From: Cam Wallace – Barker & Associates Limited

Re: Section 67 Matters – Urban Design Response

Figure 1 - Valley Park and Connected Open Spaces

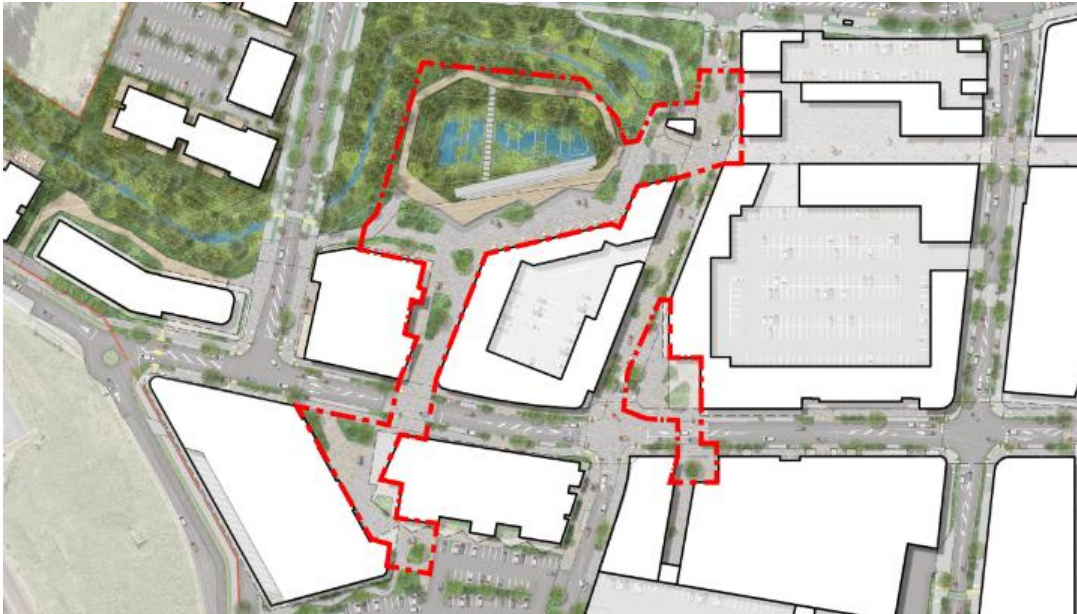
1(a) The Panel has requested further explanation of the way in which the proposed open space areas will be in accordance with what is anticipated within the Precinct and the AUP.

In terms of the specific request of the Panel as part of the s67 request, I observe that the Drury Centre Precinct Plan 2 identifies several individual open spaces, while the policy framework talks about their connectivity and integration with key site features and destinations as well as other qualitative matters. Figure 1 overleaf highlights the core network of open spaces proposed around Valley Park.

Figure 2 - Amended Lot C Pedestrian Route (and associated desire lines)

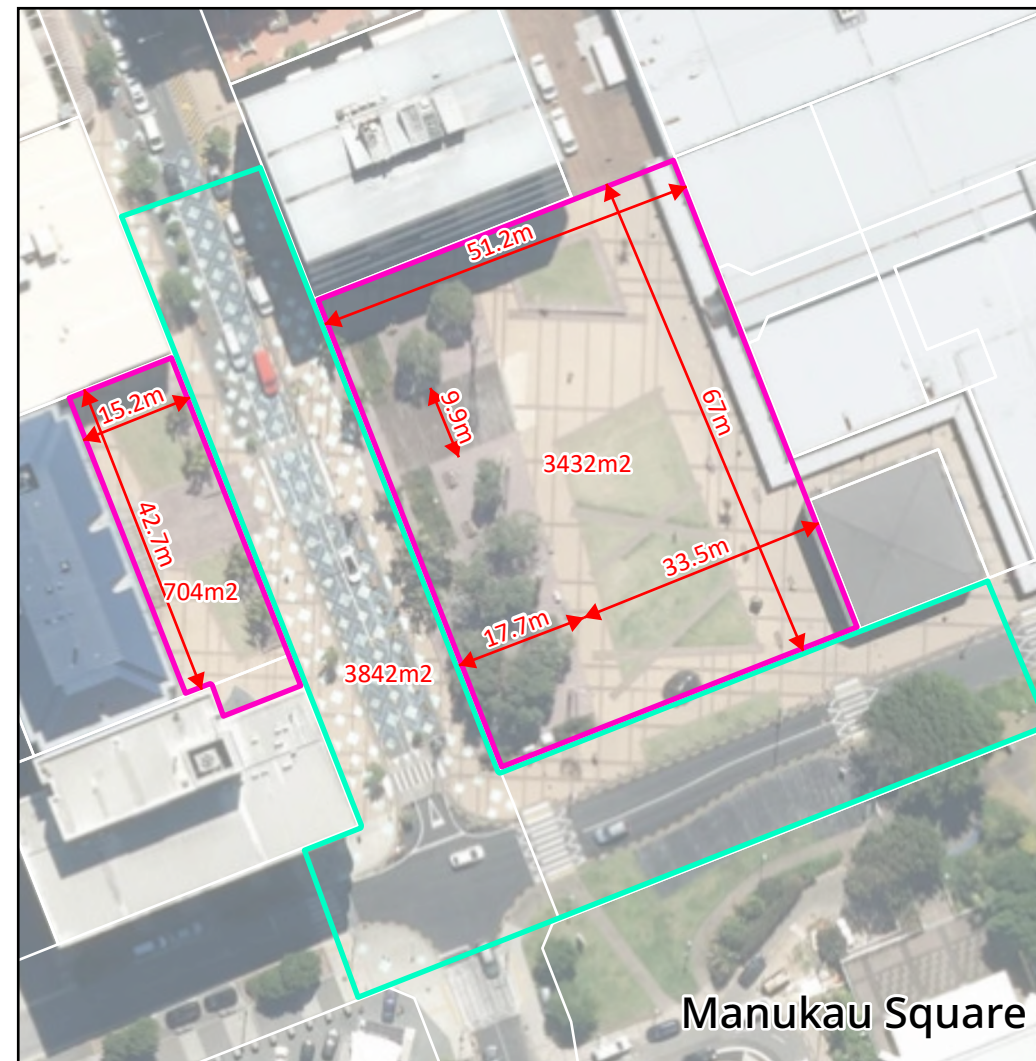
(4) The Panel also seeks consideration of an option for an improved alignment to this lot from the secondary pedestrian connection from the west (within Lot B) to Te Hononga Road, so that the internal pedestrian connection can be extended eastwards in a more logical alignment in terms of its lead-up to a relocated building entrance within Lot C.

The western "through carpark" pedestrian connection has been re-positioned to connect in with the southern arm of the intersection between Te Hononga Road, Road 13, and the Lot C vehicular access as shown in Figure 2 below. The proposed amendments to pedestrian access through the Lot C carpark ensure that pedestrian movements can be accommodated on the main pedestrian desire line from the western part of the Centre (and close to the Lot B pedestrian laneway) in a manner and location that balances the wide range of access requirements for different modes in and around the Centre.

I note that there are several conflicting design elements in this location relating to the proximity of the two signalled intersections along Te Hononga Road, Lot B carpark access, segregated cycle lanes, bus stop locations and internal Lot B pedestrian Laneway. This has resulted in several iterations and design changes through the development of the proposal prior to lodgement through to this most recent amendment. Given the competing design elements, the introduction of an additional mid-block crossing and integration with footpaths within Lot C itself was not considered an efficient or appropriate design outcome.
